NEWFIELD PRODUCTION COMPANY

WELL LOCATION, WELL 4-20-4-1,
 LOCATED AS SHOWN IN THE NW 1/4 NW
 1/4 OF SECTION 20, T4S, R1W,
 U.S.B.&M. DUCHESNE COUNTY, UTAH.

**WORKSHEET
APPLICATION FOR PERMIT TO DRILL**

Statement of Basis

EXHIBIT C

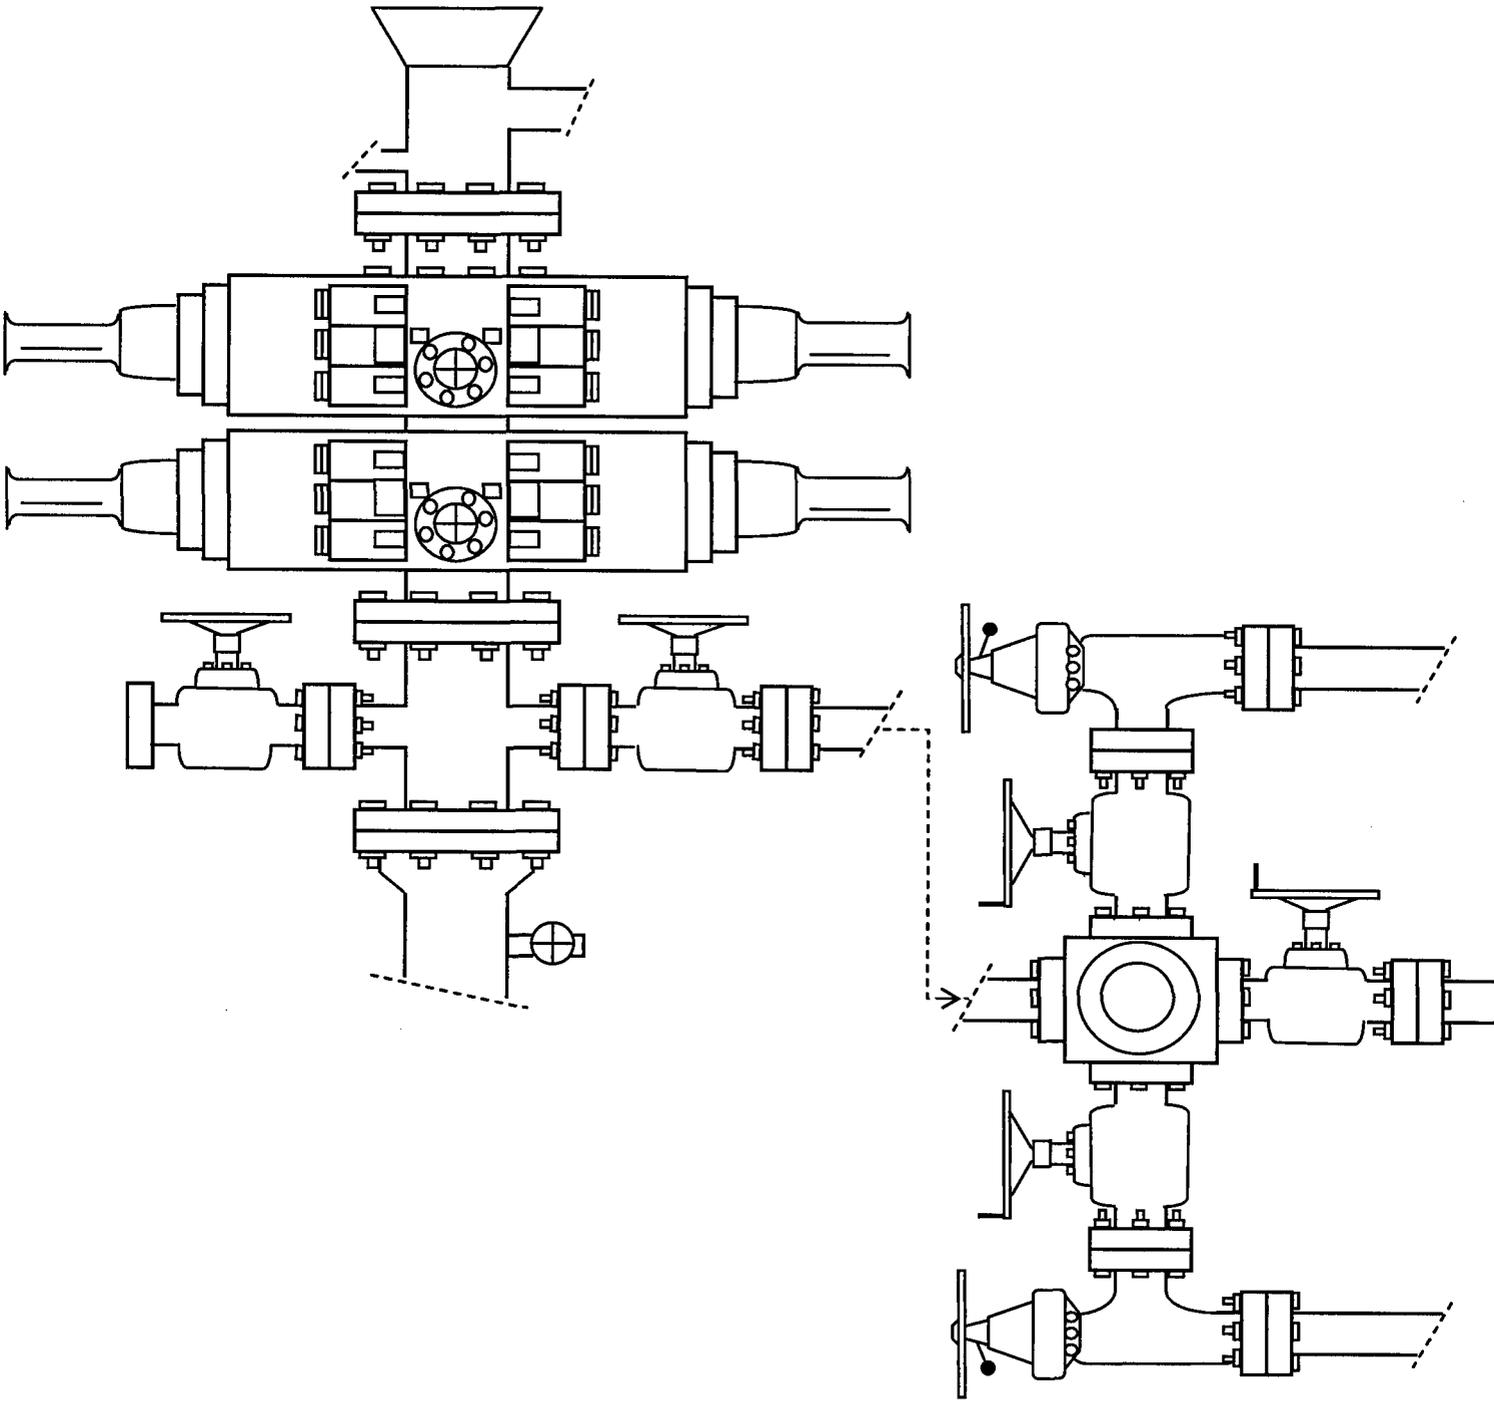
Refer to **Exhibit C** for a diagram of BOP equipment that will be used on this well.
